# Access Compliance Report

## Public Rights-of-Way

### (Curb Ramps)

Intersection ID: 28115	Main Street: DARBY_CHASE_DR	Cross Street: PROVIDENCE_GREEN_CT	Location: NW
ADA ID: 9260FA4BBF95	Ramp Type: BlendTrans1	Initial Pass/Fail: Fail	Overall Compliance: No
		Severity Score: 10

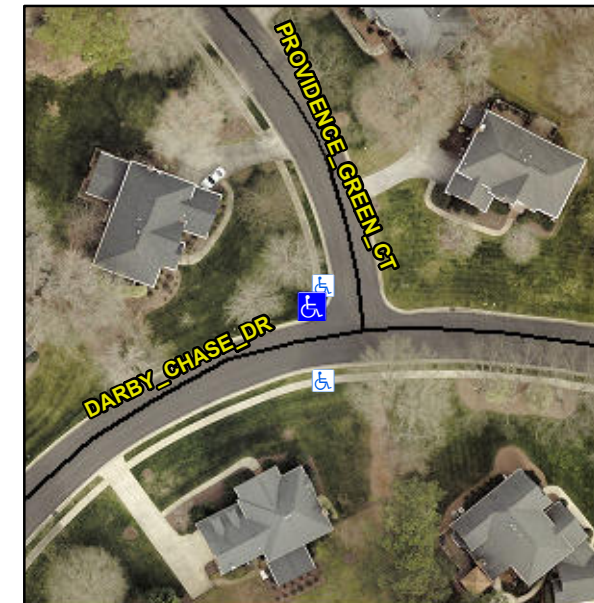
**Not Found, R304.5.1**

Compliance	Description	Data	Compliance	Description	Data
N/A	Ramp Length (in)	47.0	Yes	BlendTrans Slope (%)	2.8
No	Ramp Width (in)	40.5	Yes	BlendTrans XSlope (%)	2.6
N/A	Flare Type LT	N/A	N/A	Flare Type RT	N/A
N/A	Flare Slope LT (%)	N/A	N/A	Flare Slope RT (%)	N/A
N/A	Flare Traversable LT?	N/A	N/A	Flare Traversable RT?	N/A
N/A	Landing Length (in)	N/A	N/A	DWS Provided?	N/A
N/A	Landing Width (in)	N/A	N/A	DWS Contrast?	N/A
N/A	Landing Slope (%)	N/A	N/A	DWS Length (in)	N/A
N/A	Landing X Slope (%)	N/A	N/A	DWS Full Width?	N/A
N/A	Landing Curb? (Y/N)	N/A	N/A	DWS Offset (in)	N/A
N/A	Shared Landing?	N/A			
N/A	Gutter Ponding?	N/A	N/A	Gutter Slope (%)	N/A
N/A	Gutter Lip Ht (in)	N/A	N/A	Gutter X Slope (%)	N/A
N/A	Painted X Walk1?	No	N/A	Painted X Walk2?	N/A
	X Walk 1 Direction	To S		X Walk 2 Direction	N/A
	X Walk 1 Width (in)	N/A		X Walk 2 Width (in)	N/A
	X Walk 1 Slope (%)	2.7		X Walk 2 Slope (%)	N/A
	X Walk 1 X Slope (%)	2.9		X Walk 2 X Slope (%)	N/A

N/A	Ramp inside XWalk1?	N/A	N/A	Ramp inside XWalk2?	N/A
	Road Slope (%)	2.9		Clear Space?	N/A
	Road X Slope (%)	2.7	N/A	Clear Space to XWalk (in)	N/A
N/A	Any Obstructions?	N/A	N/A	Storm Grate/Utility Hazard?	N/A
	Obstruction Type			Storm Grate/Utility Type	
		N/A			N/A
			Yes	Surface Condition? (G/P)	Good
			No	Curb Slope (%)	14.8

**Remove & Replace Curb Ramp With Two New Directional Ramps or Equivalent.**
